**KANEPACKAGE PHILIPPINE INC.**

INVESTIGATION REPORT FORM (IRF)

Customer	BROTHER INDUSTRIES PHILIPPINES, INC.	Attention To	REXEL ALMARIO
Item Code	D038PE001	Department	PRODUCTION
Item Description	CARTON MFC-J1260W US/CAN-C	Date of Detection	251027
Job Order Number	JO25-M-03385-2A	Section Detected	QA SCREENING 3

ILLUSTRATION OF THE PROBLEM

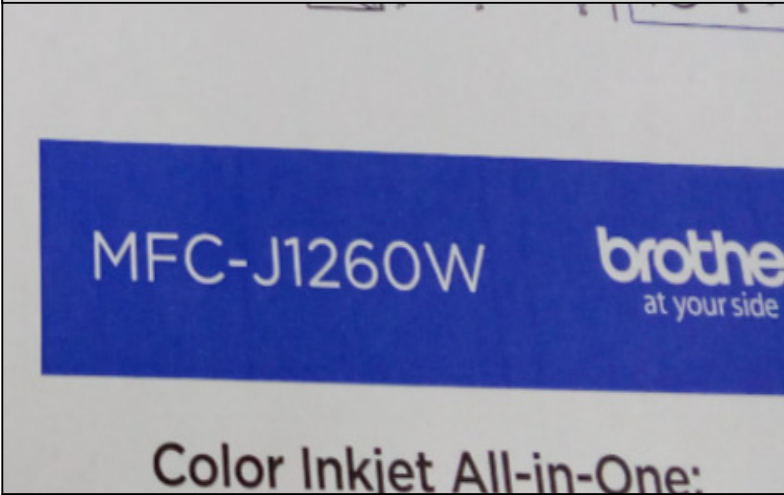
Lot Quantity (pcs)	Reject Qty (pcs)	Reject %
1187	25	2.11
Nature of Defect:		
POOR PRINT		
Requirement:		
Poor print (Light) not acceptable		
Actual		
Poor Print (Light)

WHY 1 : W1 Inconsistent application of ink to the board. r nW2 There are no controlled machine speed settings in the EQOS. r nW3 There is no established machine speed standard in the EQOS.

WHY 1: Conduct a sample trial to determine the appropriate machine speed in order to eliminate poor print.

WHY 2: Standardize the appropriate machine speed to Minimum of 120 BPM and Maximum of 200 BPM according to the result of the conducted study by incorporating them into the Eqos Work Instruction.
